Inspector General

SUBJECT: Assessment of Electrical Safety in Afghanistan
(Report No. SPO-2009-005)

Results in Brief: Assessment of Electrical Safety in Afghanistan

Figure 5. Camp Brown: Unprotected electrical component is an electrocution hazard.

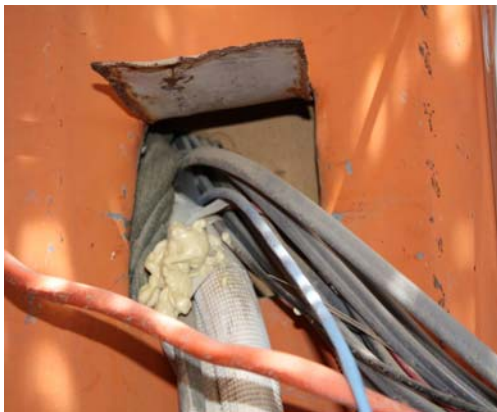
Figure 6. Camp Brown: Electrical re-wiring, to correct work performed by an untrained worker, was performed by a Seabee to prevent injury or property damage.

Figure 7. Camp Brown: The undersized wire will melt before the breaker trips causing a fire and blast hazard. Panel on the left has no dead front causing a blast hazard.

The observed conditions required immediate correction or would likely result in significant safety issues. According to the assessment team's subject matter expert, the lack of (or improper) grounding or bonding causes a shock hazard to personnel. In the absence of distribution panel doors or dead fronts for personnel protection, there was potential for direct contact by personnel to energize circuits, which could result in arc blasts and property damage. Further, unprotected electrical components may result in electrocution hazards and the use of improper electrical insulators cause fire hazards.

CENTCOM concurred. CENTCOM further stated that as of May 11, 2009, USFOR-A corrected the Life Safety deficiencies. Additionally, CENTCOM stated that the estimated completion dates for work related to major discrepancies at Camp Brown and all electrical work at Spin Boldak was May 30, 2009. On June 29, 2009, CENTCOM stated that all Life Safety issues were completed at Spin Boldak and the completion of remaining electrical deficiencies at Spin Boldak was scheduled for September 16, 2009.

Figure 8. Spin Boldak: A lack of grounding and proper bonding and undersized wires create a shock hazard.

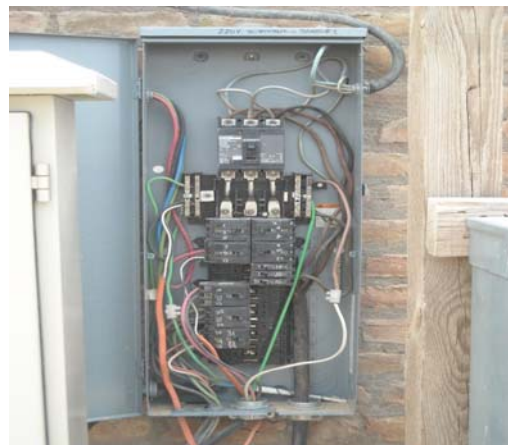
Figure 9. Spin Boldak: Exposed splices directly below an exposed straw roof create a fire hazard, and the splices are not weather-protected.

Figure 10. Spin Boldak: Connecting wires are undersized making them a fusible link, and there is no wire protection around the knock-outs at the bottom of the panel.

Figure 11. Spin Boldak: Panel doors or dead fronts missing from both panels, which increase potential for direct contact by personnel to energize circuits, which could result in arc blasts, shocks, and property damage.

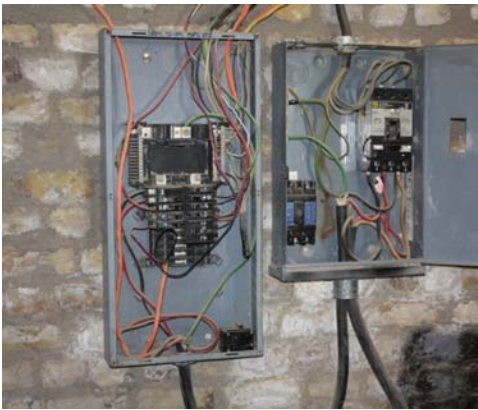
Figure 12. Spin Boldak: Taped splices (unlisted connectors) are exposed to the weather and cause an increased risk of electrocution during wet weather.

Figure 13. Spin Boldak: A sock used as an electrical insulator and an exposed splice is a fire hazard.

Figure B-9

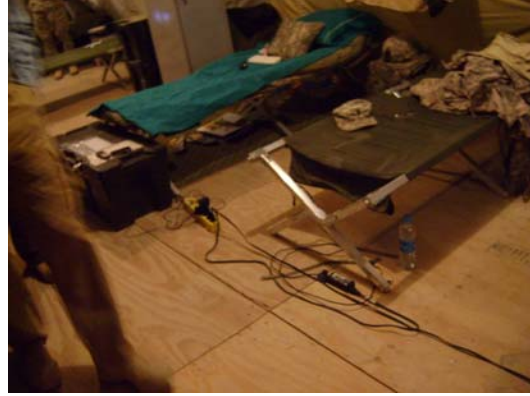
Figures B-8 and B-9 were taken of tents being used to house personnel at Kandahar Air Field. The Harvest Falcon Package is a prefab tent that holds 36 troops and comes with power strips and lighting as part of the prefabricated package. The power strip shown in figure B-9, should have been run out of the way of high traffic areas to avoid trip hazards. Additionally, the limited number of outlets for 36 personnel might encourage daisy chaining; adding additional outlets could decrease safety and electrical hazards.

Figure B-13

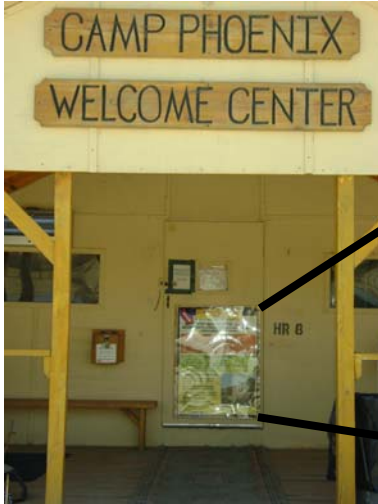
Figures B-13 and B-14 were taken of the Welcome Center at Camp Phoenix. Figure B-14 (which is a close-up photo of figure B-13) depicts a poster containing information on electrical safety and hazards. Specifically, the poster discusses electrical hazards related to low-hanging overhead electrical power lines.
